Office Action Summary

10/727,809

LENK, FRITZ

Fig. 3A

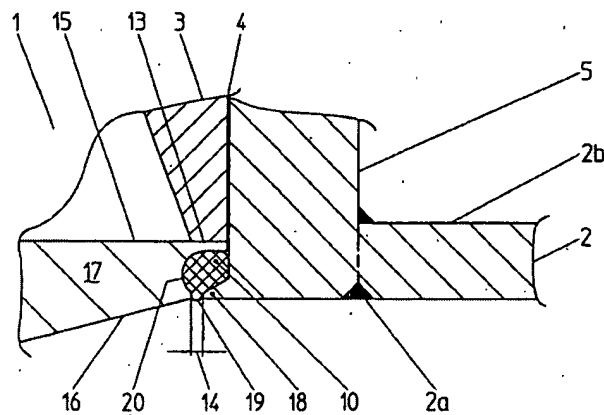
The Prior Art fails to disclose a tank opening or process for installing a level measurement

device having a clearance area (element 14 of Figure 3 of the instant application) with the seal pressing into the clearance area.
